CITY PLANNING COMMISSION

- APPLICATION:
1. Negative Declaration
 2. Rezone 65.3± vacant acres zoned Single-Family (R-1) and Townhouse (R-1A) to Single Family (R-1) exclusively
 3. Tentative Map to resubdivide 65.3± vacant acres into 301 lots for single family residential development
 4. Subdivision Modification to create lots in excess of 160' in depth

LOCATION: West of Deer Lake Drive, east of WPRR, north of Union House Creek

TENTATIVE SUBDIVISION MAP

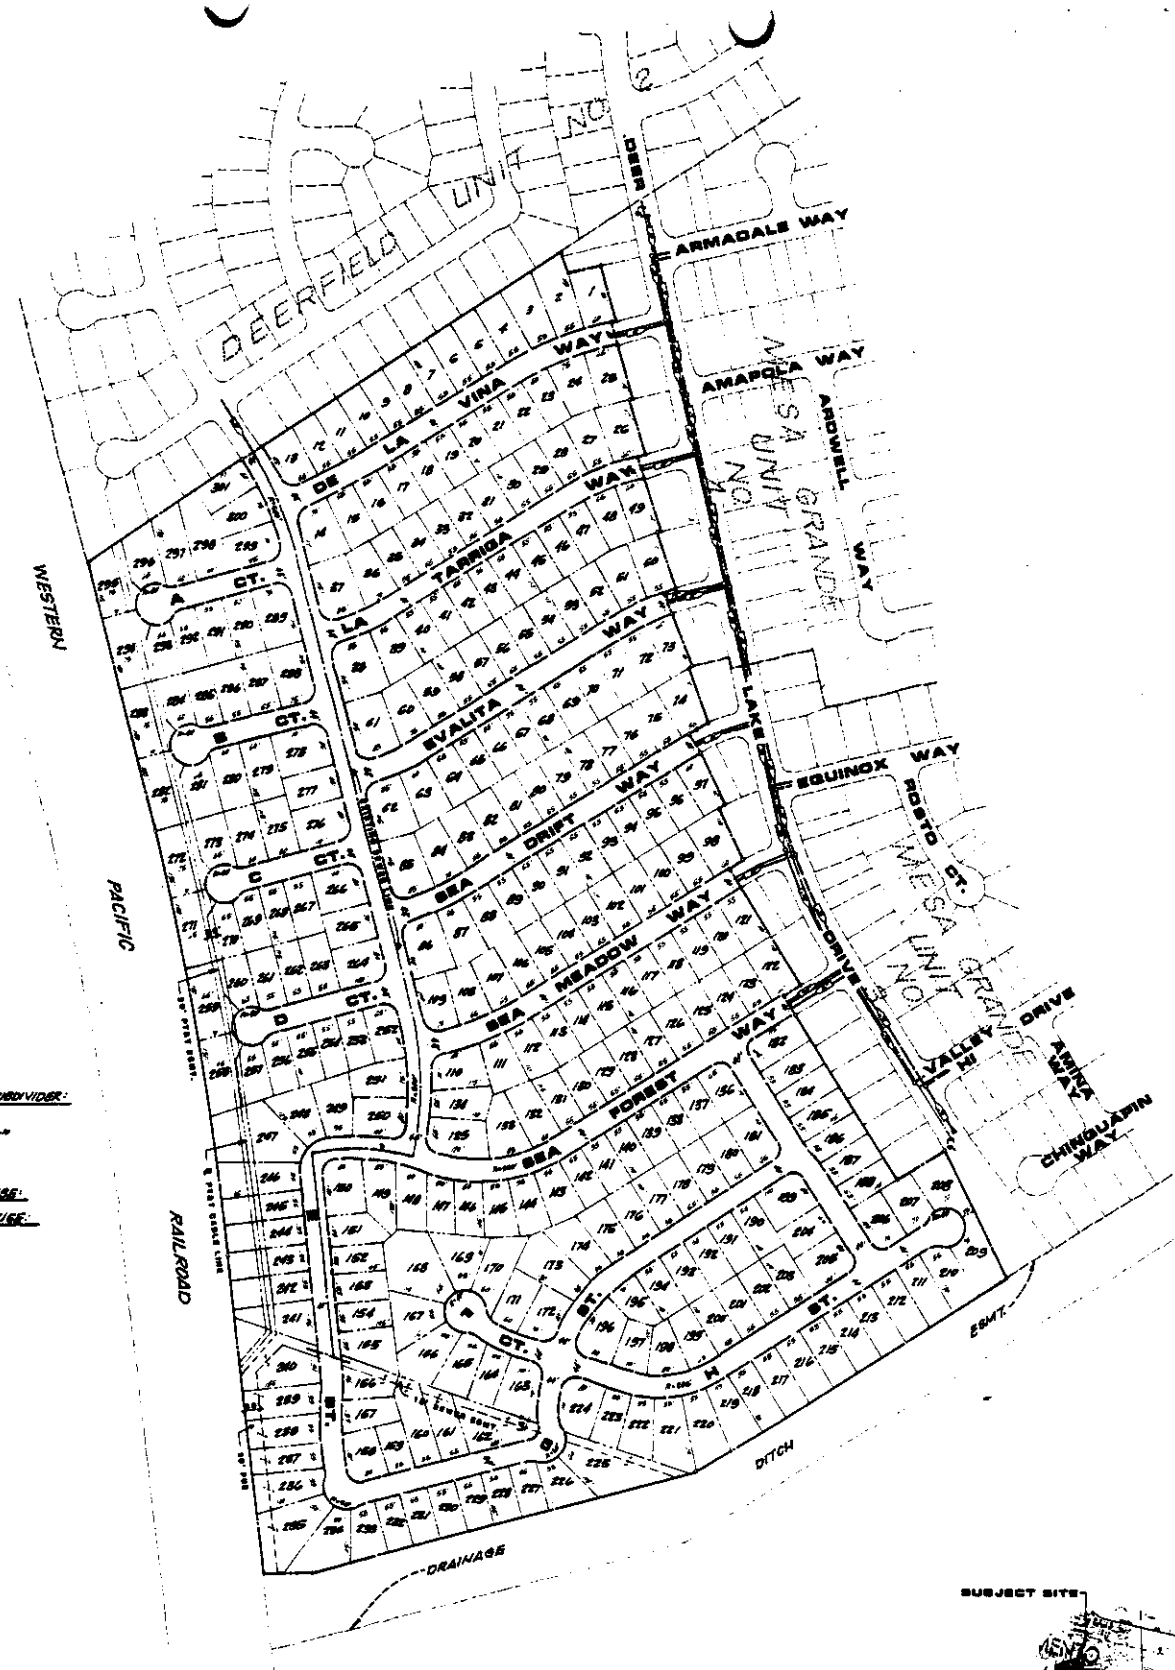
1. Provide standard subdivision improvements pursuant to Section 40.811 of the City Code;
2. Prepare a sewer and drainage study for the review and approval of the City Engineer; may require relocation of existing sewer across lot 156;

7. Provide knuckle transitions at 90° turns.

1. The Environmental Coordinator has determined tht the proximity of the proposed project to the Western Pacific Railroad tracks may expose people to severe noise levels. However, the following mitigation measure will reduce the exterior noise levels to less than a significant impact.

"The applicant shall provide an accoustical study assessing the proposed project for consistency with the 1975 City General Plan Noise Element subject to review and approval by the Planning Director prior to filing the final map. Noise mitigation measures, if required, shall be indicated on the final map." The staff requests that if a sound barrier is required by the accoustical study, that the sound wall be constructed of decorative solid masonry material.

2. The Planning and Community Services Departments have determined that 2.77 acres are required for parkland dedication purposes based upon the revised tentative map. The subdivider shall submit to the City an appraisal of the land to be subdivided. Said appraisal shall be dated and submitted no more than 90 days prior to filing the final map with the City Council.
3. The staff has no objection to the proposed rezoning and changes to the tentative map to permit all single family uses. The proposed project is compatible with the surrounding development and the current community plan which designate the site for low density residential.
4. Lots 225 and 250 have lot depths greater than 160 feet. Staff has no objection to the subject deep lots in that the proposed lotting pattern and street configuration does not permit standard lot depths.

- A. Provide standard subdivision improvements pursuant to Section 40.811 of the City Code;
- B. Prepare a sewer and drainage study for the review and approval of the City Engineer; may require relocation of existing sewer across lot 156;
- C. Pursuant to City Code Section 40.1302 (Parkland Dedication), the applicant shall submit to the City an appraisal of the property to be subdivided and pay the required parkland dedication in-lieu fees. The appraisal shall be dated not more than 90 days prior to the filing of the final map;
- D. Pursuant to City Code Section 40.319-1, the applicant shall indicate easements on the final map to allow for the placement of centralized mail delivery units. The specific locations for such easements shall be subject to review and approval of the City Engineer after consultation with the U.S. Postal Service;

- E. The applicant/developer shall designate and place on the final map those structures and/or lots which will meet the required eighty percent (80%) south orientation (including solar access) to the satisfaction of the Planning Director;
- F. Prepare a sound study regarding the Western Pacific Railroad tracks. The study shall be approved by the City/County Health Department and the City Planning Department. Noise mitigation measures, if required, shall be indicated on the final map. If a sound barrier is required, the applicant shall construct a wall out of solid decorative masonry wall material. The design and details of the masonry wall shall be submitted to the Planning Director for review and approval prior to recordation of the final map.
- G. Provide knuckle transitions at 90° turns.
